ACTION MEMORANDUM and DECISION DOCUMENT
TIME -CRITICAL REMOVAL ACTIONS
FOUR METAL SITES (SEADs 24, 50/54, & 67)

**FINAL
ACTION MEMORANDUM
TIME-CRITICAL REMOVAL ACTIONS, FOUR METAL SITES**

**SWMUs SEAD-24, SEAD-50/54, and SEAD-67
SENECA ARMY DEPOT ACTIVITY**

**Response to the Comments from the New York State Department of Environmental
Conservation and Department of Health**

FIGURE 2-3
PROPOSED REMOVAL
ACTION AREAS

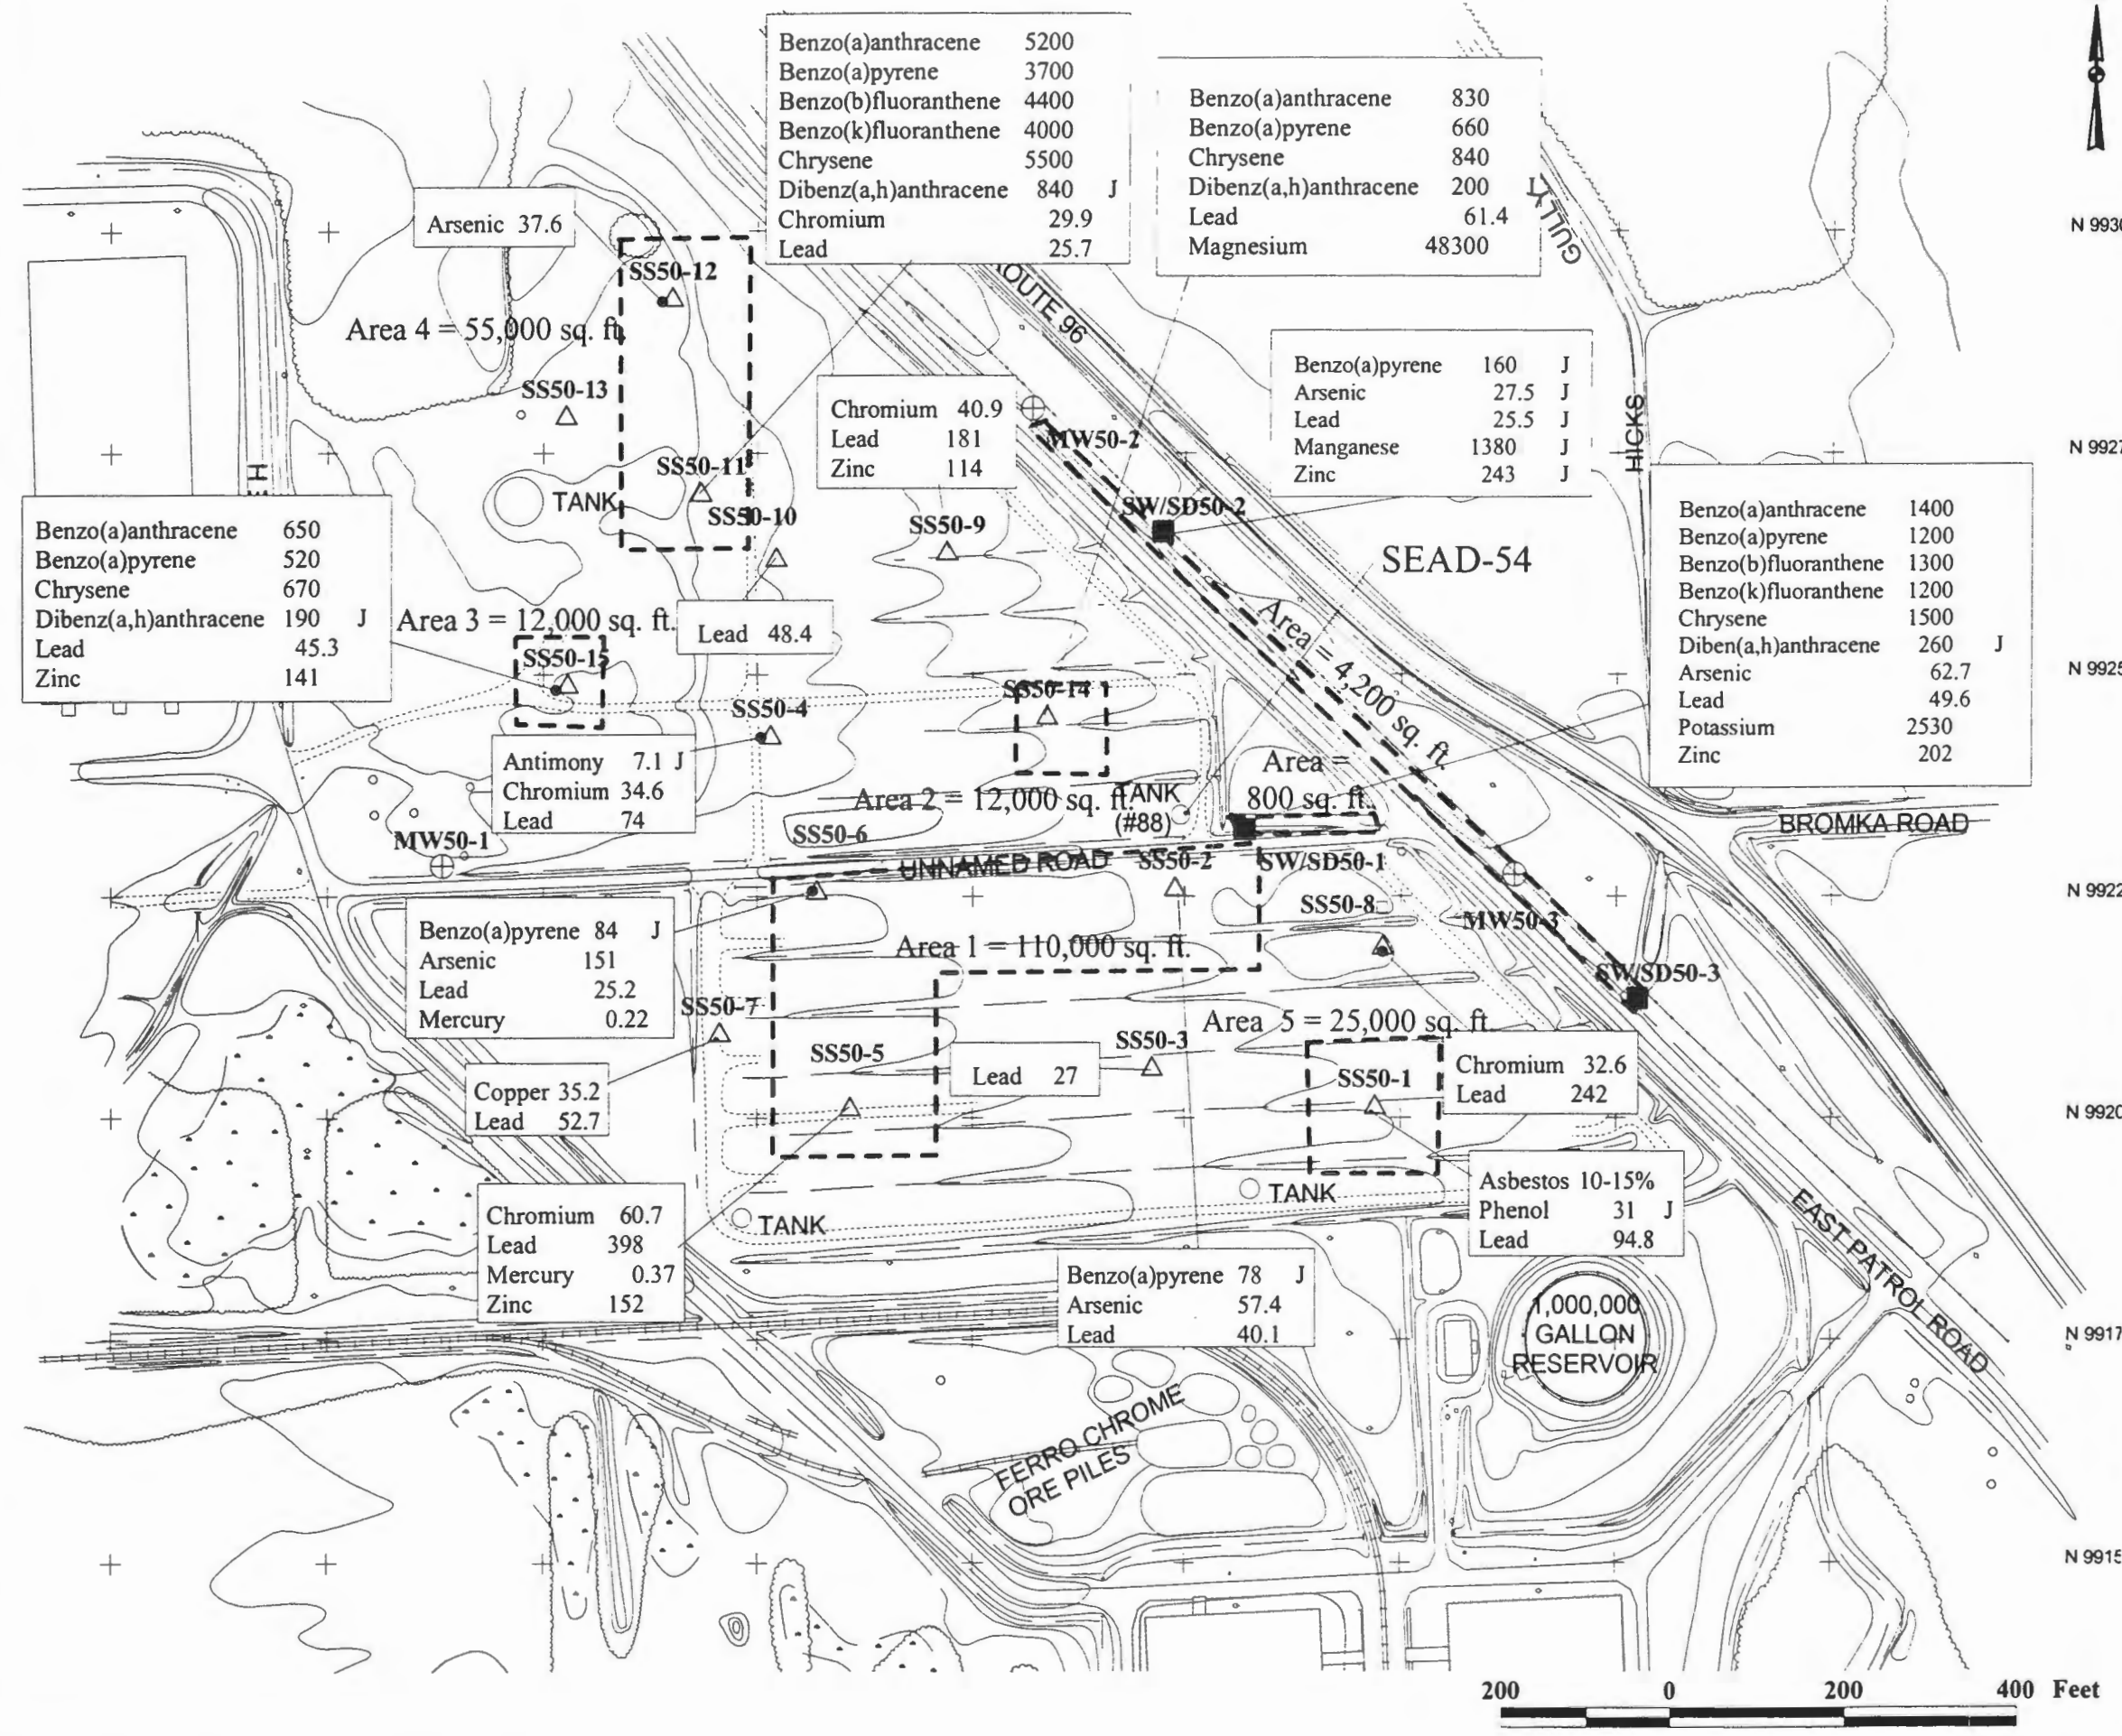
In addition, the text on Page 2-8 of this section details five distinct areas of SEAD-50 that will undergo removal actions. However, Figure 2-3 shows six areas. A description of the drainage ditch excavation (shown on Figure 2-3 to be an estimated 4,200 sq ft) is missing from the text. While the Army has revised its original excavation plans to postpone the

In actuality, Figure 2-3 displays seven areas where excavations will be conducted. The seventh area is a second drainage ditch that is located northeast of Area 1, and encompasses roughly 800 square feet of land. A discussion of the proposed removal action for soils in the drainage ditch is provided in the paragraph following the one presenting details of the fifth area of the Tank Farm. This was provided on page 2-9 of the draft final Decision Document for SEAD-50/54.

FIGURE 3-1
 SITE MAP - SEAD-67

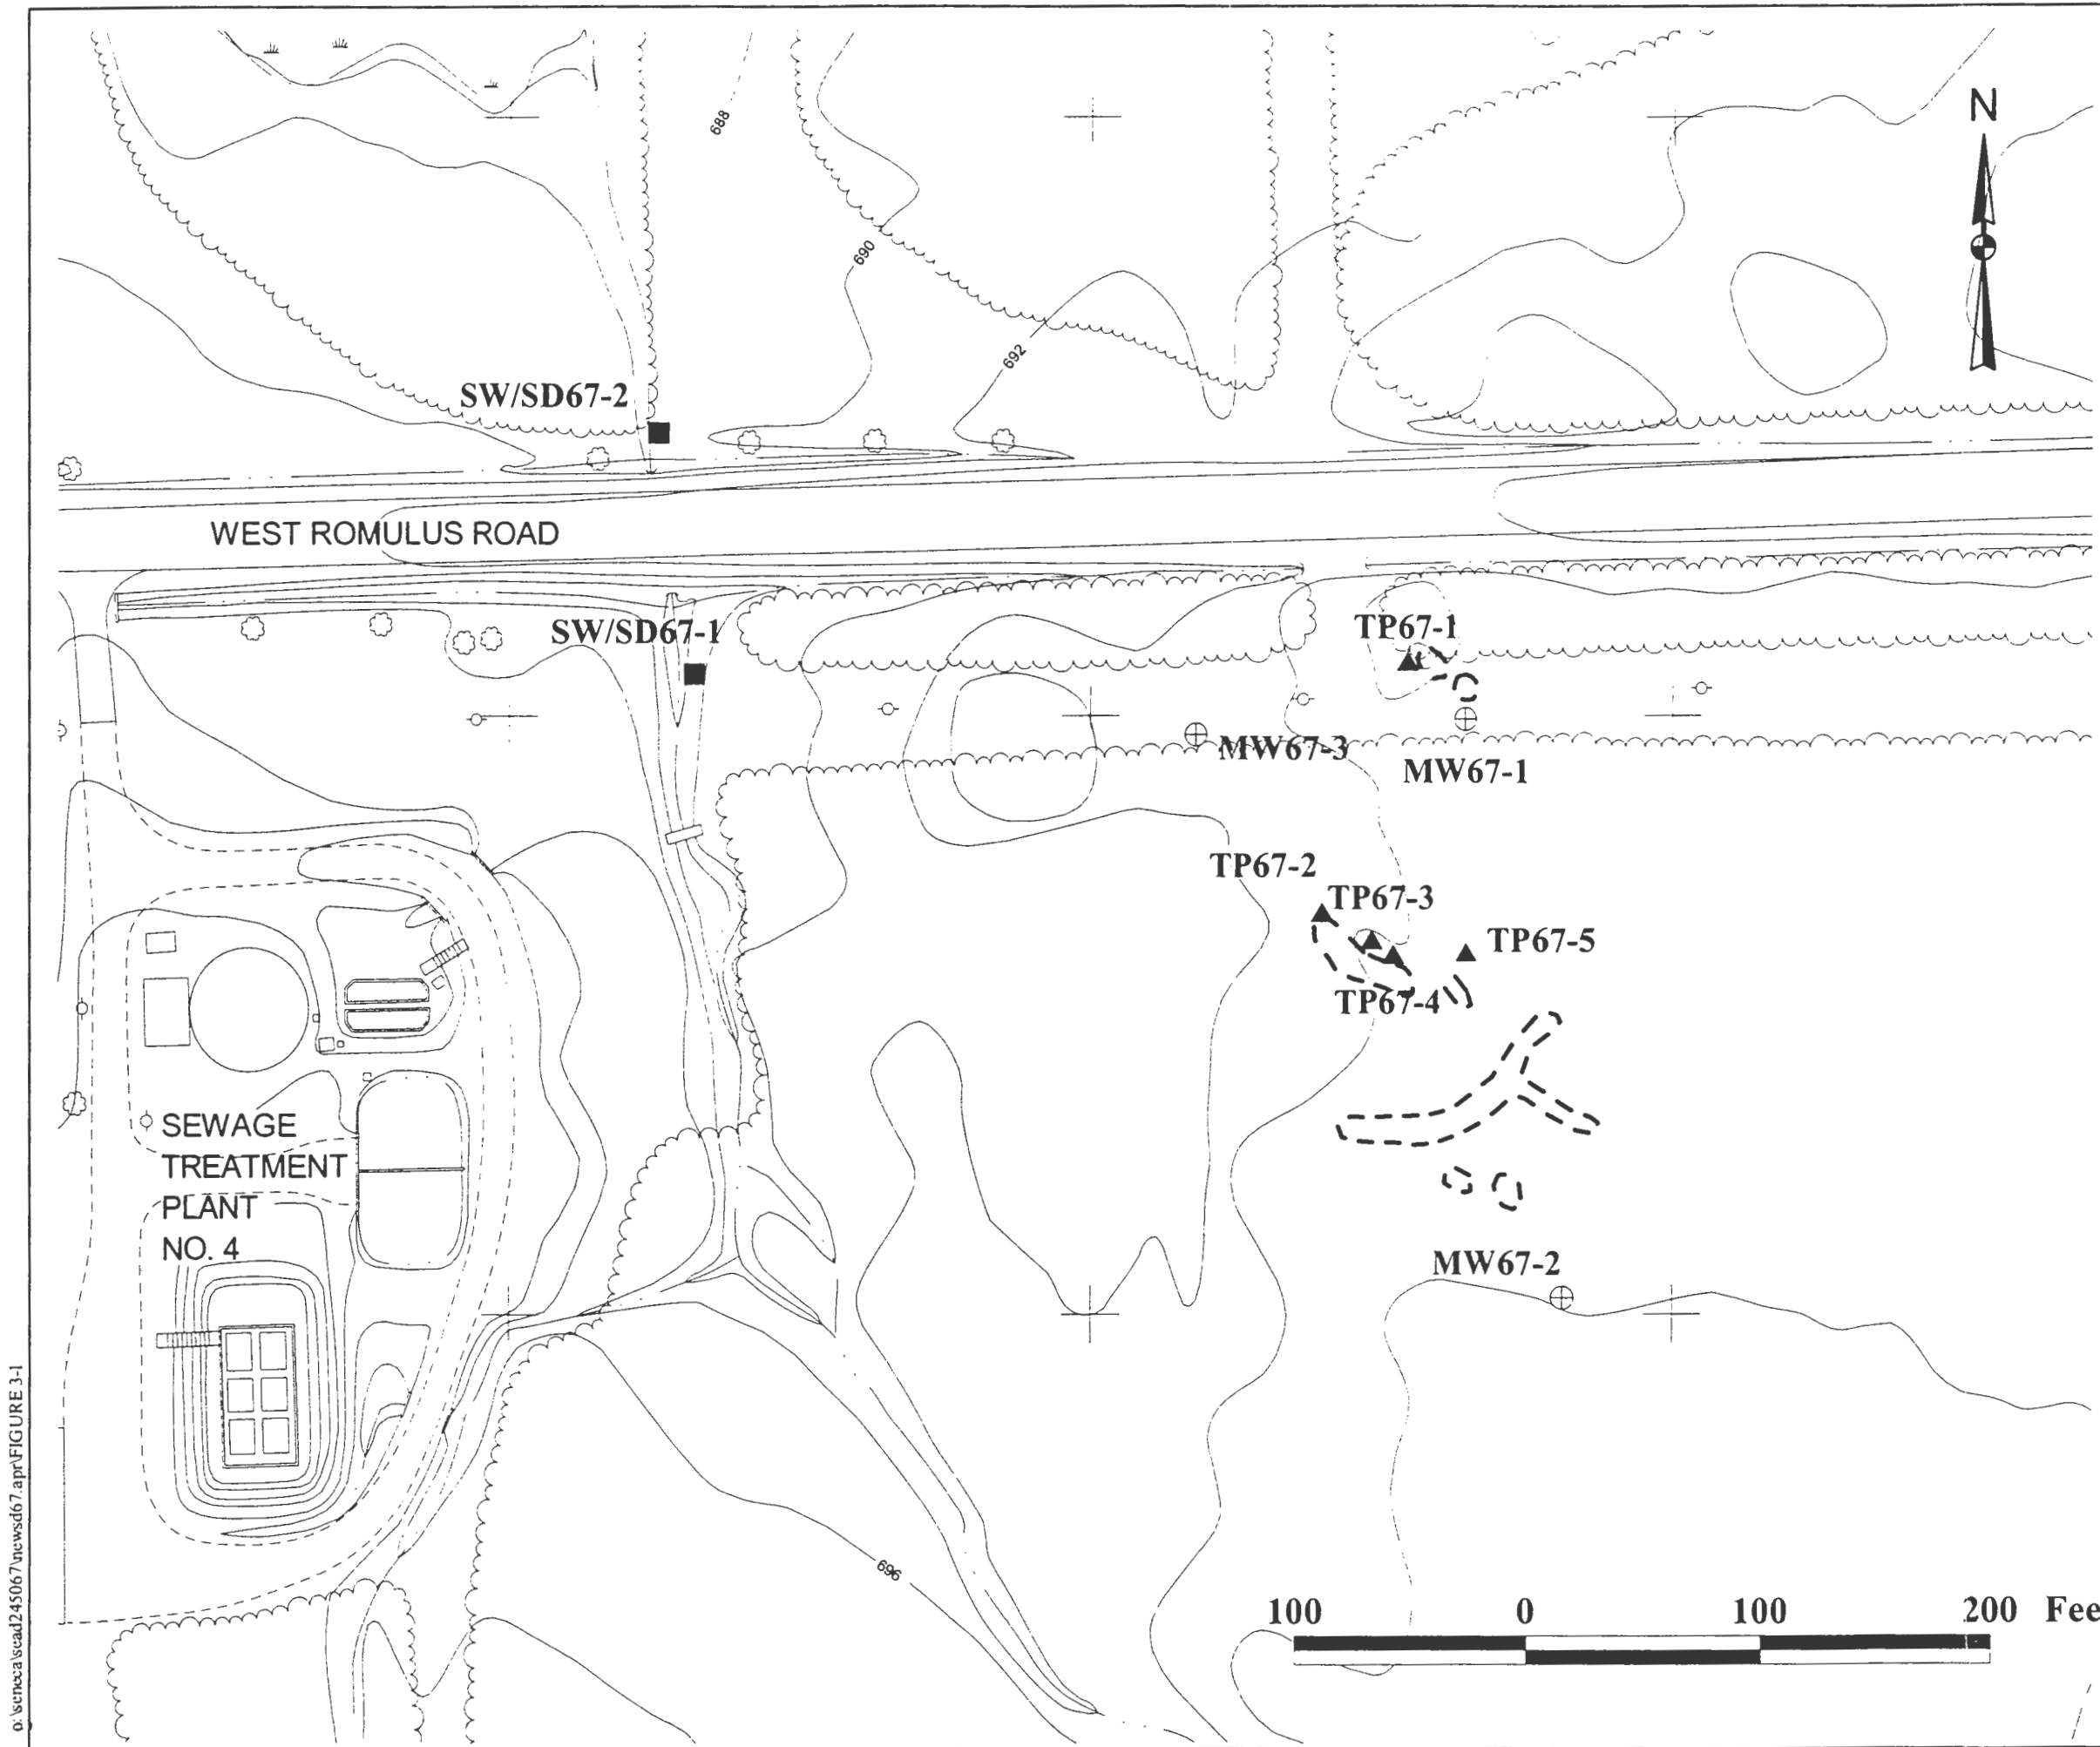
2. It is stated in the site description section that waste piles and berm locations are shown as dotted lines in Figure 3-1. Unfortunately, Figure 3-1 does not contain any dotted lines depicting waste piles and berm locations. Please revise this figure.

Outlines depicting the approximate extent of the piles have been added to Figure 3-1.
